LOT #3-63
WHITE TAIL RIDGE 3
NEWINGTON (GARAGE RIGHT)
OPTIONAL CHEF'S KITCHEN

REVISED: MAY 7-24

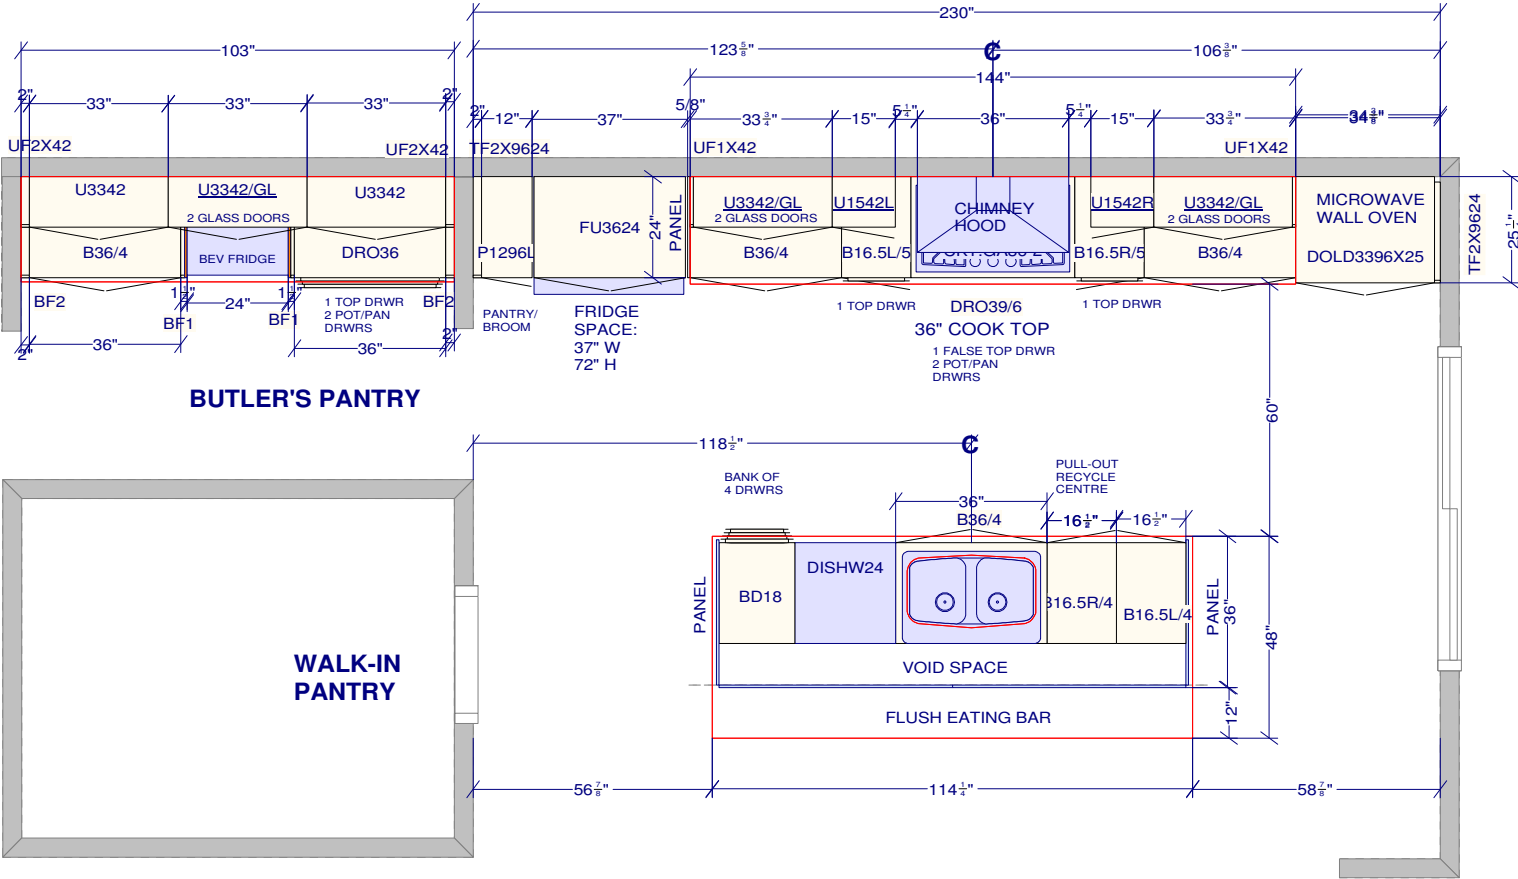
~~FILL TO CEILING WITH
PLAIN PANEL IN MATCHING MATERIAL
& COLOUR TO CABINET DOORS
RECESSED APPROX. 1/2" FROM FRONT OF CABINET BOX~~

FILL TO CEILING WITH PLAIN PANEL FLUSH
TO CABINET DOORS
PANEL IN MATCHING COLOUR AND FINISH
TO CABINET DOORS

FRIDGE / COOKTOP / OVEN WALL ELEVATION

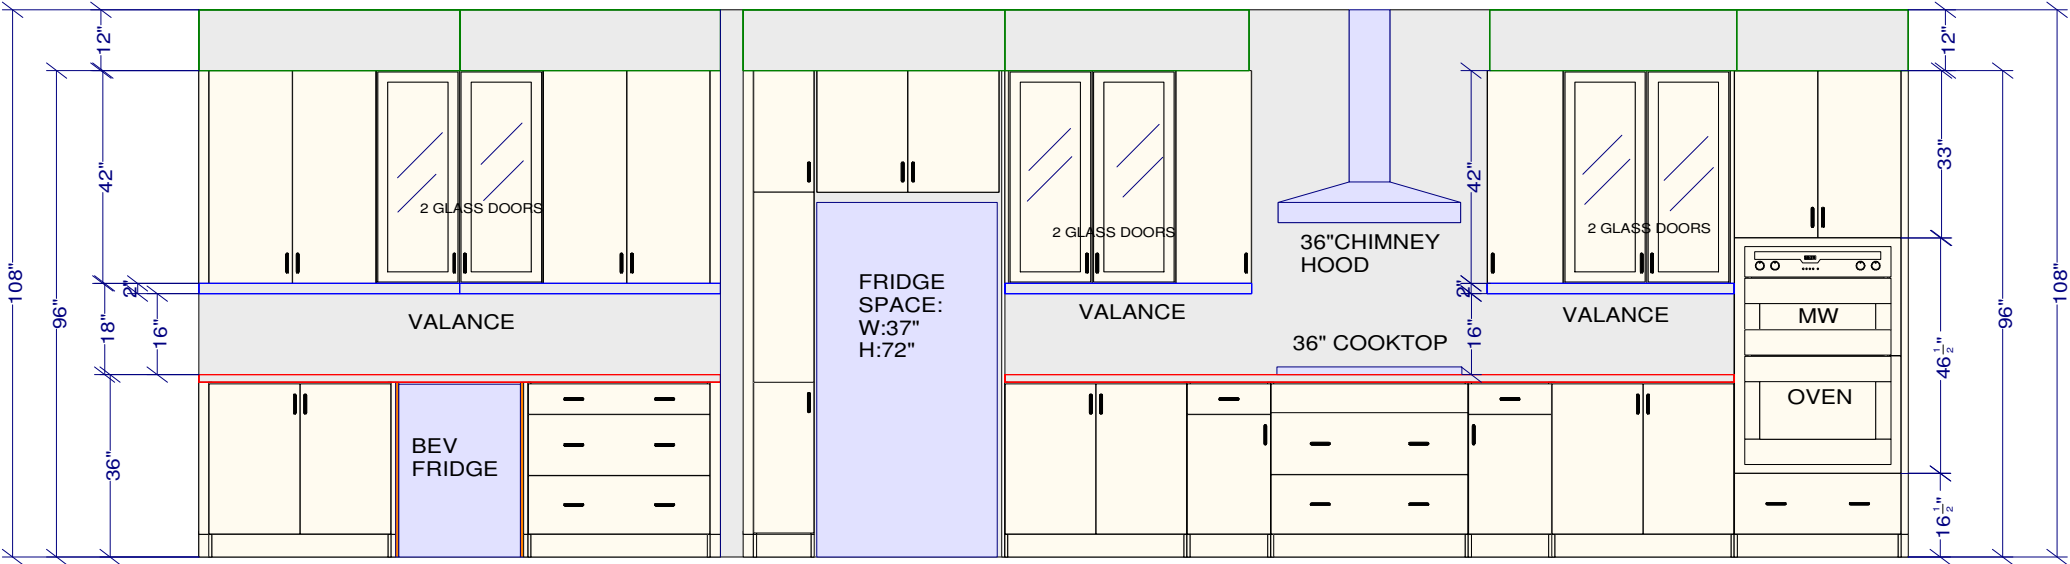
~~FILL TO CEILING WITH
PLAIN PANEL RECESSED APPROX. 1/2"
FROM FRONT OF CABINET BOX~~

FILL TO CEILING WITH PLAIN PANEL
FLUSH TO CABINET DOORS
PANEL IN MATCHING COLOUR AND
FINISH TO CABINET DOORS
